Antenna Information for Council planners

Dave Westrup
Radio Design
05.06.2020

Antenna Coverage and Design – Camden Planners Questions

Antenna Coverage – Correct Vertical Orientation of Antennas

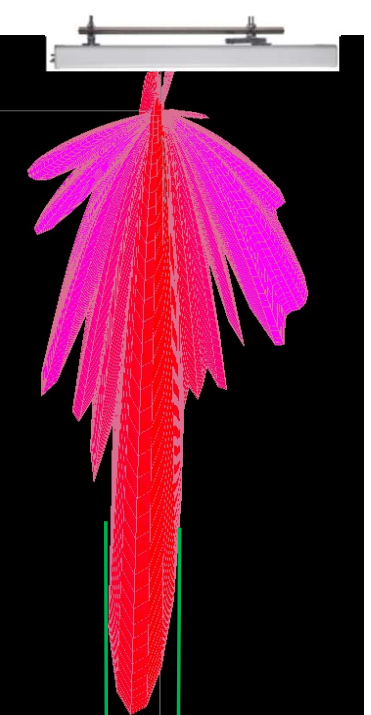
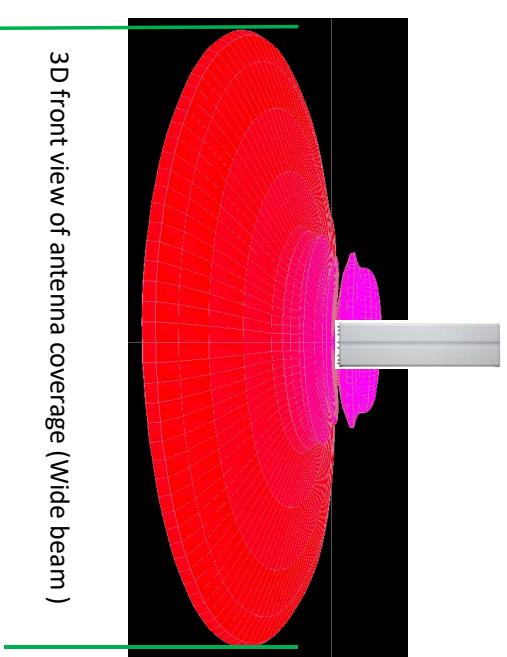
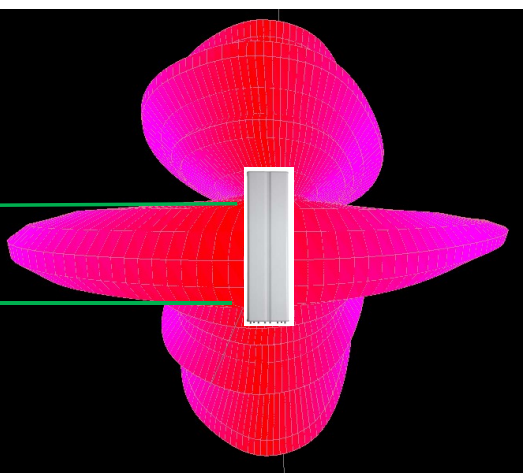
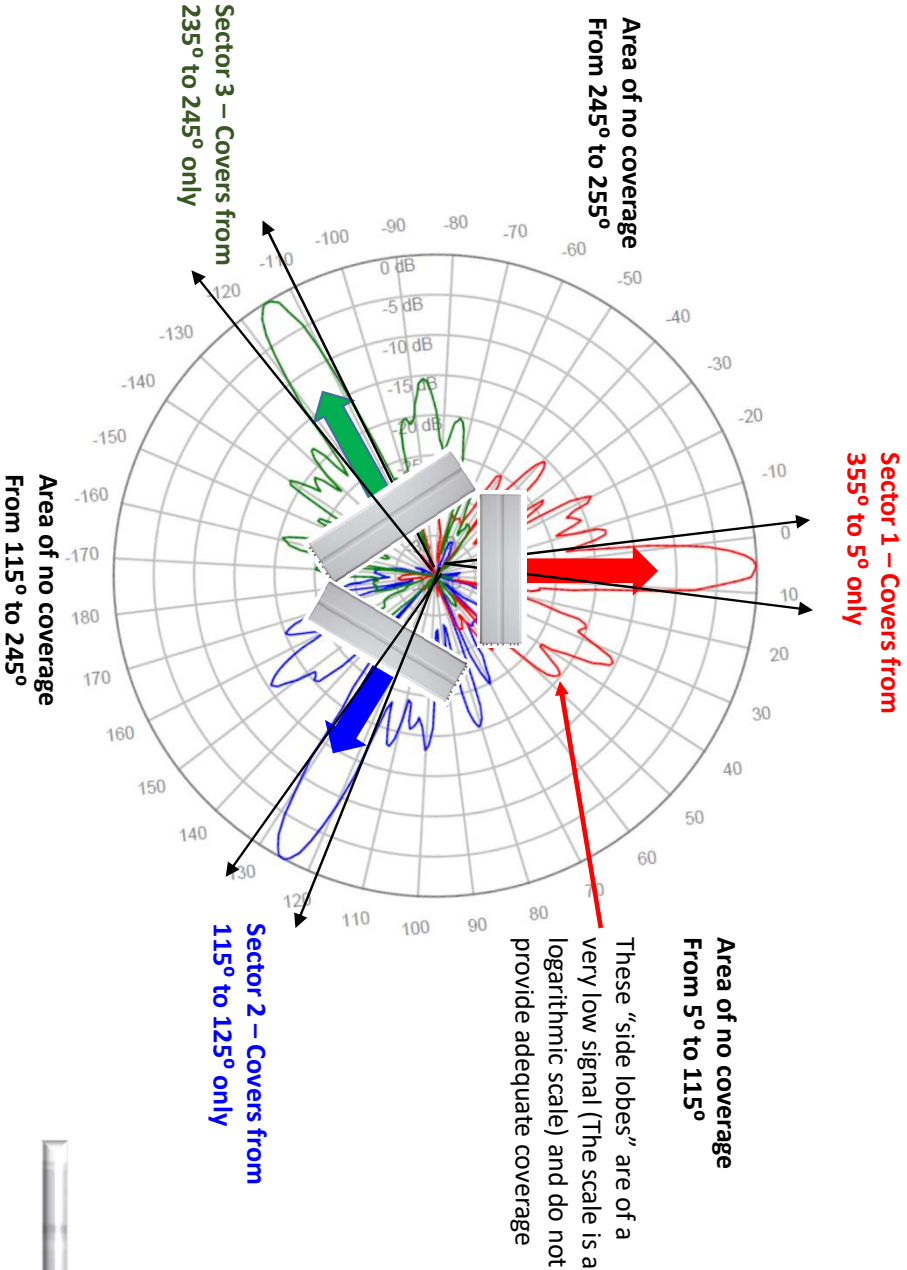
1. Camden do not believe that antennas cannot operate horizontally. Could you explain why antennas are not installed horizontally, and the ramifications if we were to adopt such a configuration?

Plan view (Birds eye view) of a 3 sector (antenna) cell site with *correct* vertically mounted antennas

Each antenna covers a nominal 120° area, so 3 antennas, mounted 120° apart, covers the full 360° area. The antenna coverage is similar to a disc, or plate, it is very wide (120°) in the azimuth (Horizontal plane), and very narrow (10°) in the elevation (vertical plane)
